To: Traffic Orders, City of Edinburgh Council

Spokes objects to the Traffic Regulation Orders as presented, regarding the items listed below. However, we do support the intention to control parking/waiting/loading at these locations.

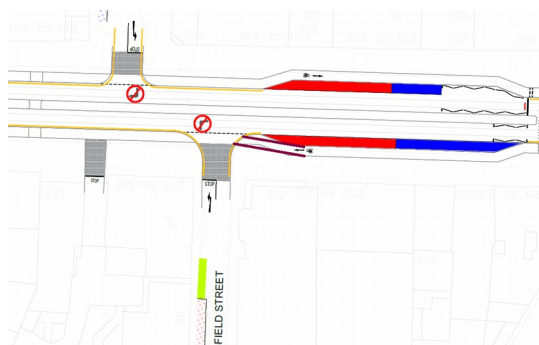
1. The placement of the yellow lines across the foot/cycleways on Leith Walk at locations shown as "Pedestrian Priority Crossings"  
The yellow lines should continue along Leith Walk and across the entrance to the side street rather than curving around and across the cycle/footway (*See illustration from Robert Weetman "Nicer Cities, Liveable Places"*). This is to visually reinforce that pedestrians and cyclists have priority over motor turning motor vehicles and to allow the footway and cycleway to appear continuous.
